We thank the editor and the anonymous reviewer 2 for their valuable and constructive comments which substantially improve our revised manuscript entitled: "Technical note: A low cost, automatic soil-plant-atmosphere enclosure system to investigate CO₂ and ET flux dynamics.". We have carefully addressed all comments of both reviewers. Please note the color code in our point-by-point answer below:

Figure 2 Schematic representation of the wiring of one Greenhouse Coffin in the dependent mode.

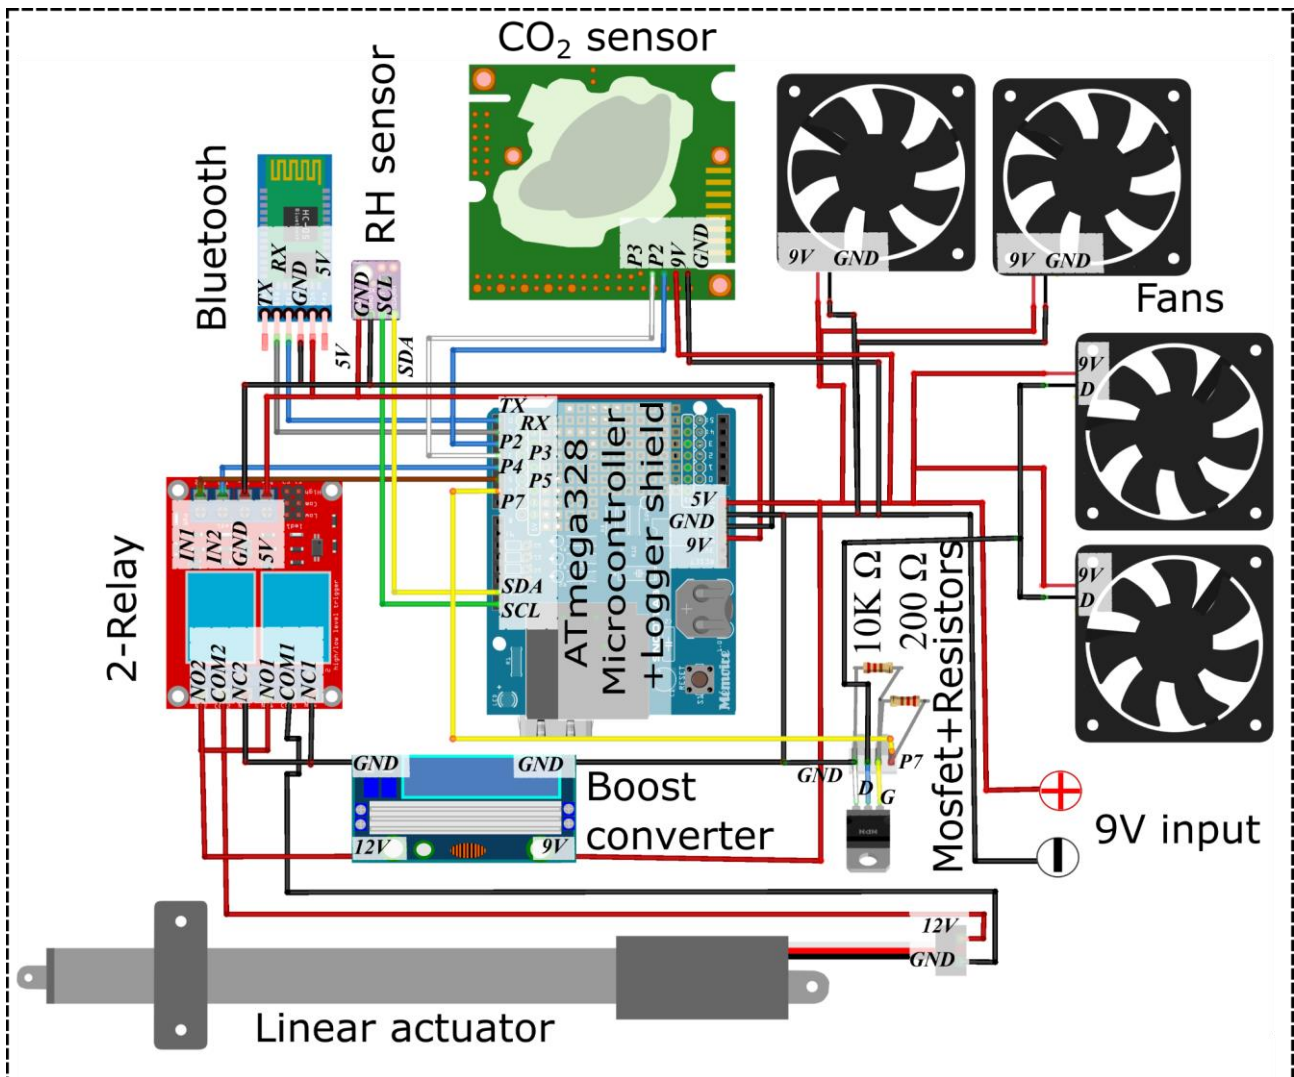
The schematics in Fig. 2 are of little use: at first sight, they appear detailed, but the small scale of the images makes deciphering the precise connections difficult or impossible. A proper schematic drawing (describing which pins on the microcontroller are connected to which pins on the relay board, for example) should be made available along the Arduino microcode to enable readers to build systems of their own.

We agree and will provide more detailed schematics to make it easier to follow. Additionally, pin connections are provided now within the schematic (before only given within the Arduino code, which is available through a DOI link). We will update the manuscript accordingly to include these details, ensuring that readers have all the necessary information to build and understand the system. Please see the updated figure below.

Figure 4: 1:1 agreement between the mixing ratio and the measured ΔCO_2 concentration change expressed as in ppm, was obtained during the laboratory validation.

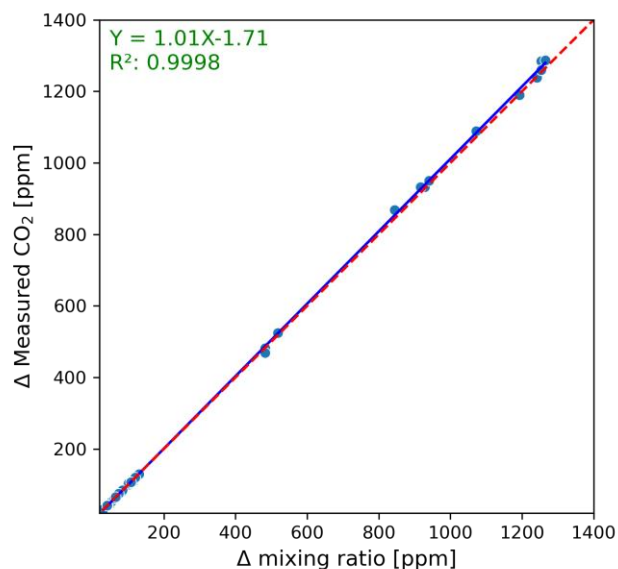
5.) The method for testing the sealing of the system is seriously lacking: a smoke bomb creates aerosols, which are multiple orders of magnitude larger than the CO₂ and H₂O molecules which are the object of measurement here. The proper way of estimating leak (which is unavoidable in a system like this!) is to create a large mixing ratio of CO₂, such as 1000 or 2000 ppm, in the chamber and then monitor the development of the mixing ratio within the chamber compared to the surrounding mixing ratio (ppm s⁻¹ delta_ppm⁻¹, where ppm is the mixing ratio within the chamber and delta_ppm is the difference between the outside and inside). Thus, a solid estimate of the proportion of air exchanged between the measurement system and the ambient atmosphere can be made. The same method can be used to estimate the rate of leakage between the chambers in multi-chamber mode, without the need to use a semi-random factor such as plants in the process. The method of leak evaluation chosen by the authors is not proper for the job. A small difference between mixing ratios on the inside and outside makes leaks nearly undetectable.

In addition, we extended the magnitude of our leakage test with CO₂ injections, as requested, to a larger mixing ratio of CO₂ (1000 ppm) and will use it to update Figure 4 accordingly. The test results showed no significant difference (pairwise Wilcoxon signed-rank, $p > 0.05$) between ΔCO_2 measured by the LI-850 and the calculated mixing ratio. As previously concluded, this suggests the proper sealing of the coffin. See updated Figure 4 below:
